#### NOTES FROM MEETING

23 April 2012 – 8.00am City of Joondalup

Item 1 PROPOSED CHILD CARE CENTRE AND CAR PARK ADDITIONS TO THE JOONDALUP HEALTH CAMPUS, CORNER OF UPNEY MEWS AND LAKESIDE DRIVE, JOONDALUP

Ground Floor Plan

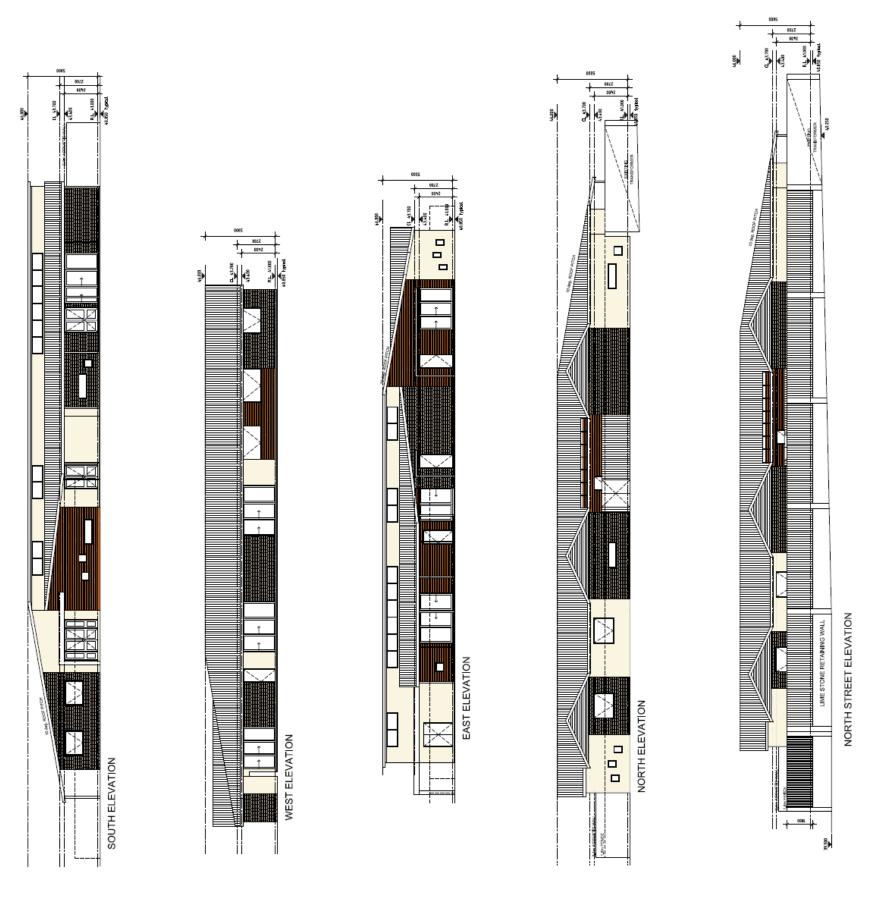
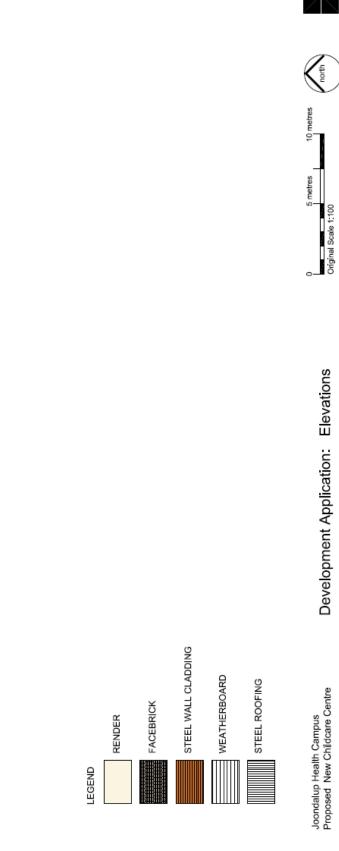
- Queried the area of land on Lakeside Drive outlined in red on the development plans and if there are landscaping plans for this area as indicated.
- Queried the car park development situated over the sump and the height of the car park. The Panel advised that it needs careful design consideration and maintenance of the area.
- Queried the justification behind varying the standards relating to the design of the pitched roof to such a significant extent.

The Panel were concerned that the design was not addressing the streetscape or solar access. The Panel advised that there was a lost opportunity by not using the northwest corner as it would provide better light and wind protection.

The Panel agreed that the materials appear to fit in well with the palate of the current hospital buildings, however, due to the pitched roof, the building may appear to look like a shed from the streetscape of Upney Mews.

The Panel noted that the pitched roof appears to go down into a solid fence, with no windows.

The Panel gueried why there was such a large variation on the roof pitch.

The Panel queried the service gate indicated on the development plans.

The Panel raised concerns with the high fence located on Upney Mews. The Panel suggested that the design be made "softer" with a small garden/terrace house garden appearance that won't impact on the use.

Response: Due to acoustic studies, the northeast corner was chosen. The northwest location was working well until the acoustic report was received. Due to the location of play equipment and noise issues, the design team had to reconsider the design, and essentially mirrored their original proposal to be focussed towards the south of the site.

Response: The design team agreed with this comment and will review the design. They will try and break up the roof form to reduce its monolithic appearance.

Response: The architect advised that the design team are currently looking into that issue, as the acoustic barrier (solid fencing) is not necessary on the Lakeside Drive frontage. The fencing along Upney Mews will also be revisited.

Response: Due to the width of the building, didn't want the appearance to look too bulky.

Response: The service gate will be deleted from the plans.

Response: Design team have noted the comment made and it will be considered, including the use of trees and shrubs that grow and drape over the wall.
